172-174 St. John St.

Warehouse Expansion

Redlon + Johnson

Bill, I have reviewed the Stormwater report and corresponding plans dated December 21, 2000 by Alliance construction for the Redlon and Johnson Project and provide the following comments: 1. the applicant has proposed the use of pipe tees and casco hoods as their means of providing water quality treatment and sediment removal from stormwater runoff. In my opinion these measures do not satisfactorily meet the City's standard for stormwater treatment. The past precedent set by the Planning board for similar projects has been to require a manufactured treatment device such as a vortech chamber, a Downstream Defender or other equal structure. My specific concerns on the proposed tees include the installation of a tee on the RCP type pipe and exactly how that connection would be made. Secondly, the structures contain 21" pipe therefore if the existing structures are only 4' dia. the tee will be difficult to fit in the structure. The tee will also hamper long term maintenance and the ability to extract sediment out of the sump. 2. The plans do not contain information as to the existing sump depths of the structures. 3. the plan

E:\Land Projects\Redion -- Johnson\dwg\Redlon-Johnson Site GRADING.dwg, 12/20/00 11:37:44 AM

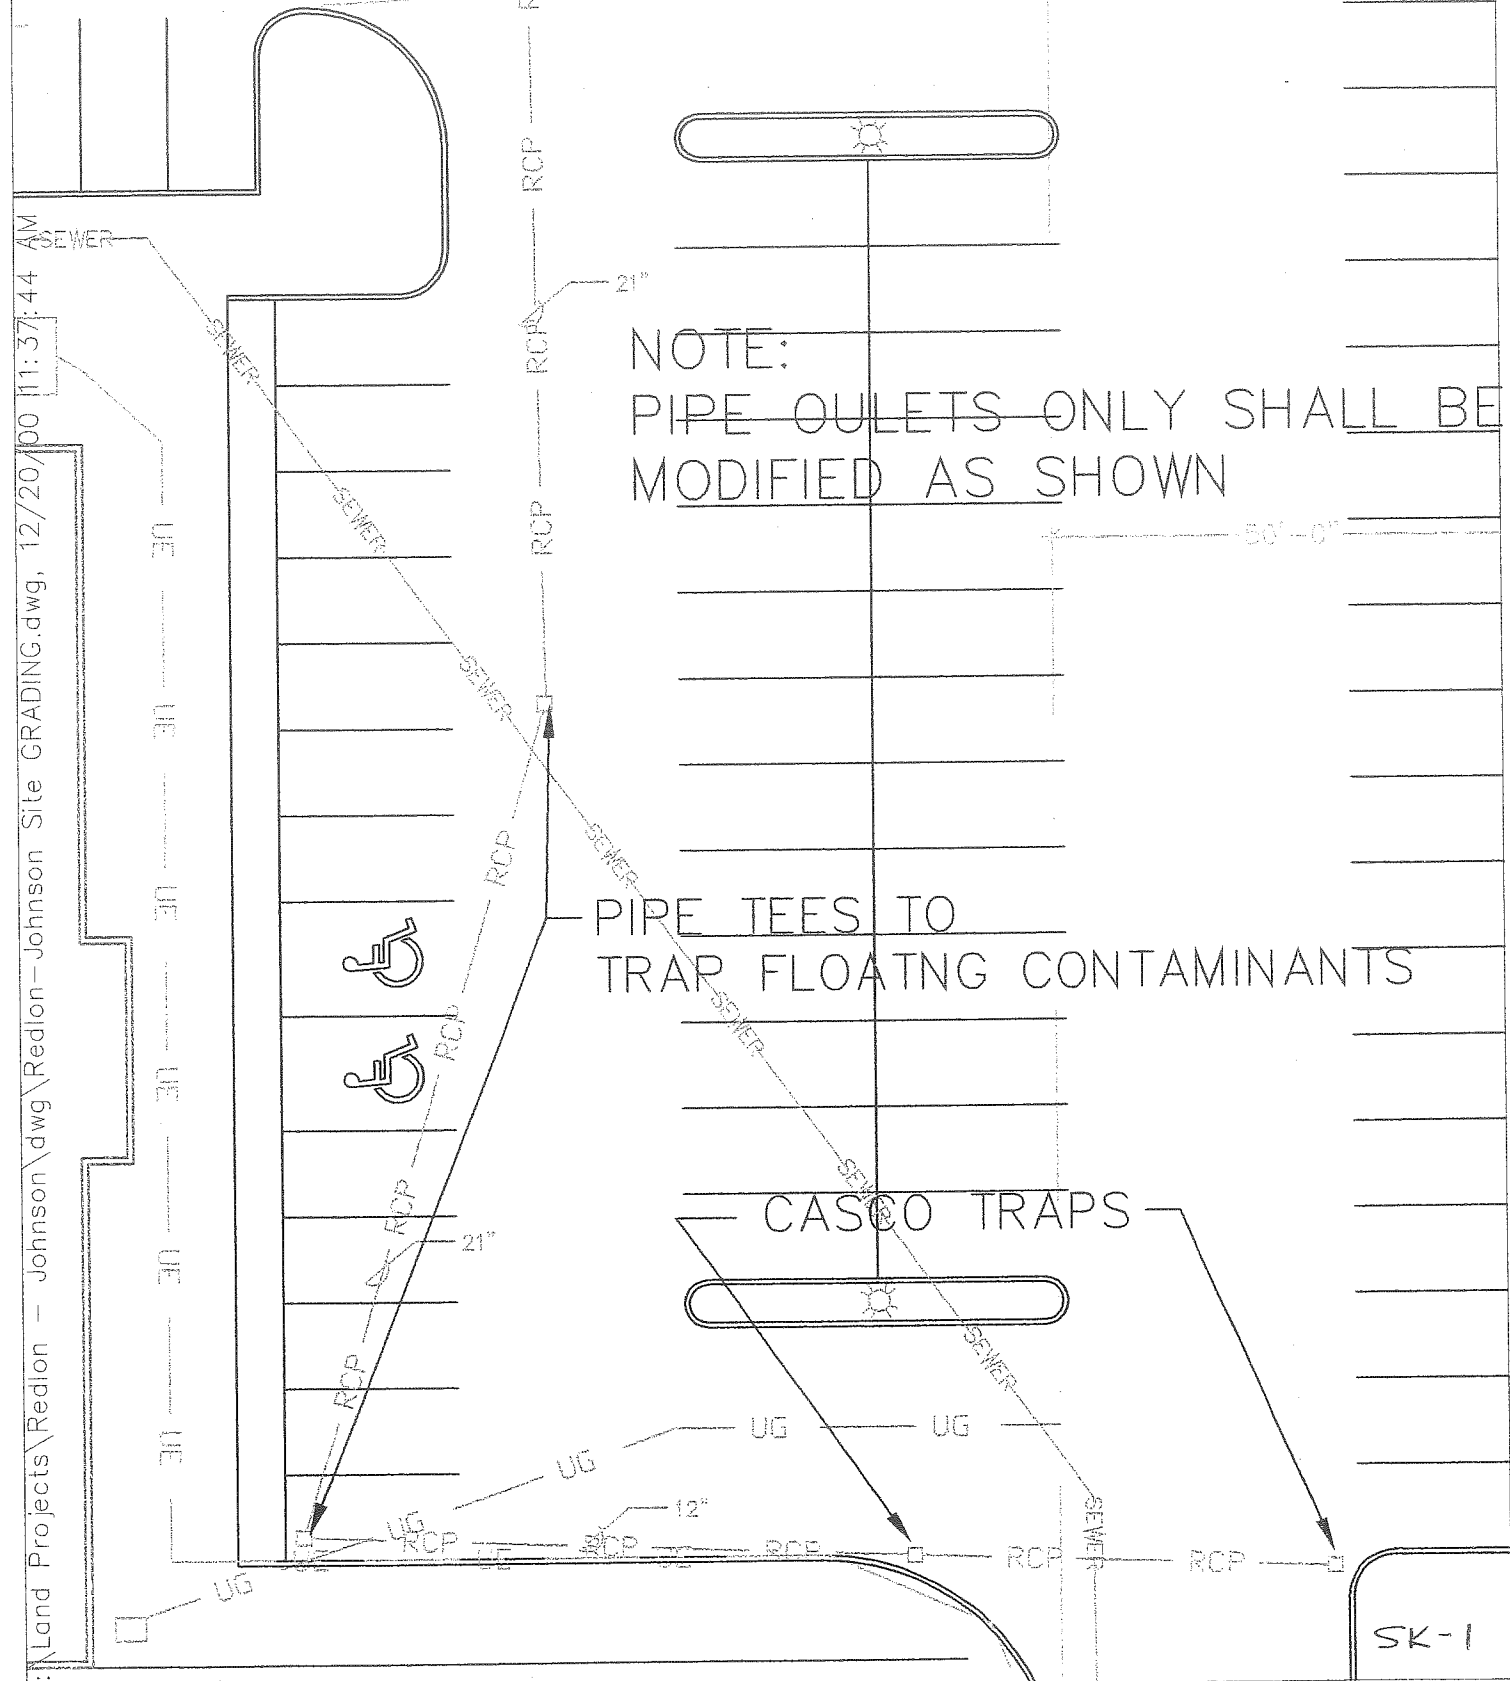
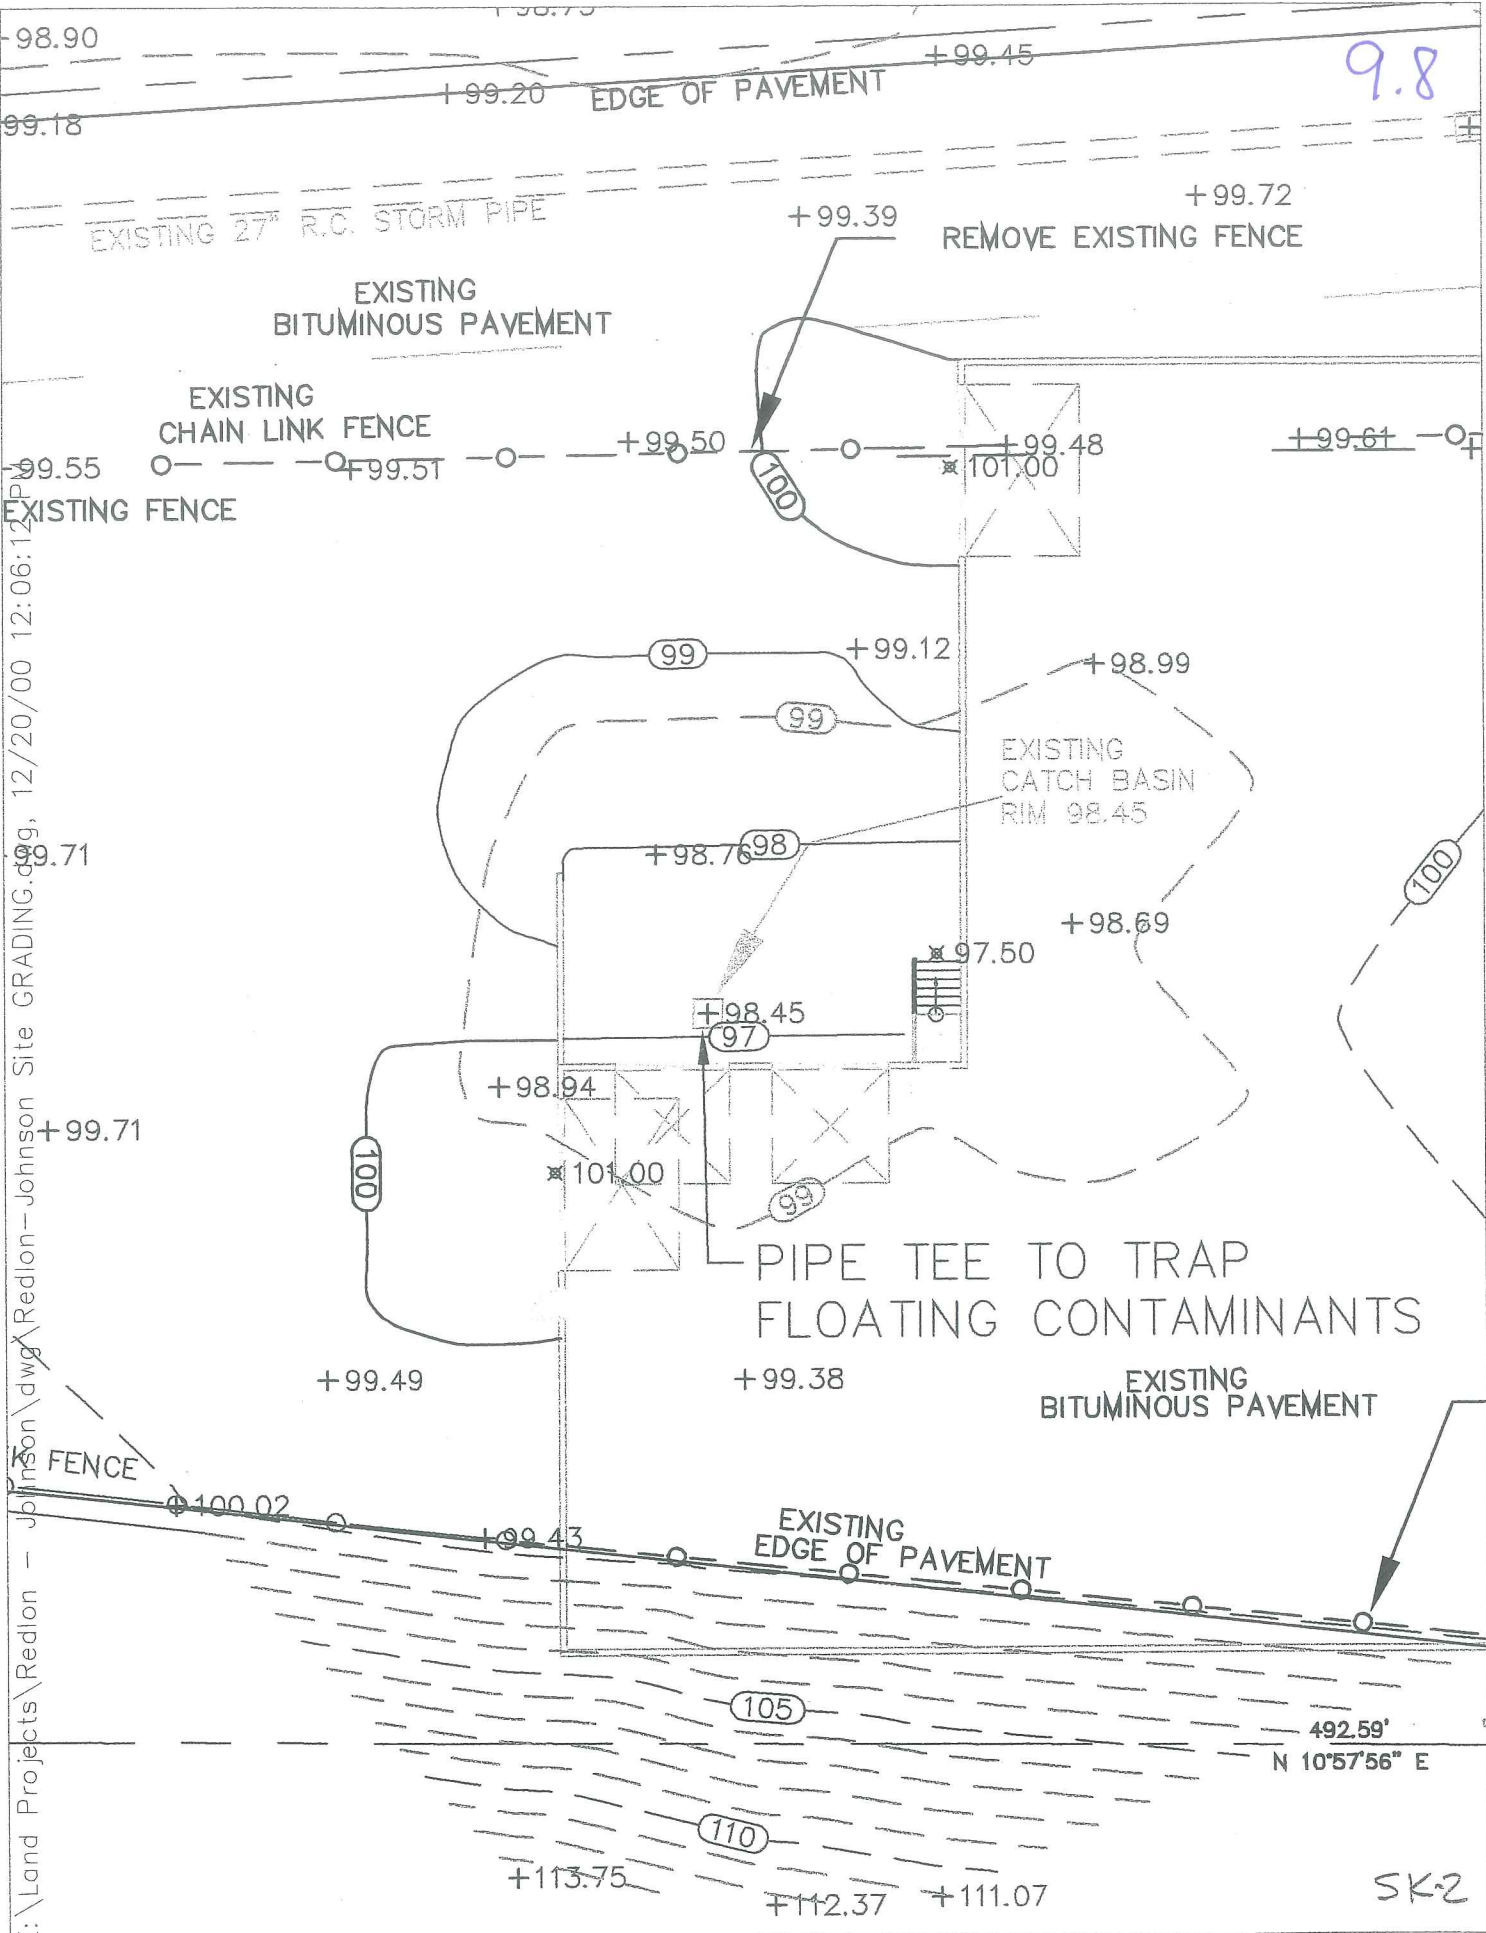
1. the applicant has proposed the use of pipe tees and casco hoods as their means of providing water quality treatment and sediment removal from stormwater runoff. In my opinion these measures do not satisfactorily meet the City's standard for stormwater treatment. The past precedent set by the Planning board for similar projects has been to require a manufactured treatment device such as a vortech chamber, a Downstream Defender or other equal structure. My specific concerns on the proposed tees include the installation of a tee on the RCP type pipe and exactly how that connection would be made. Secondly, the structures contain 21" pipe therefore if the existing structures are only 4' dia. the tee will be difficult to fit in the structure. The tee will also hamper long term maintenance and the ability to extract sediment out of the sump.

2. The plans do not contain information as to the existing sump depths of the structures.
3. the plan does not show the pipe connection from the truck well catch basin to the storm drain pipe. This information should be added to the plan.
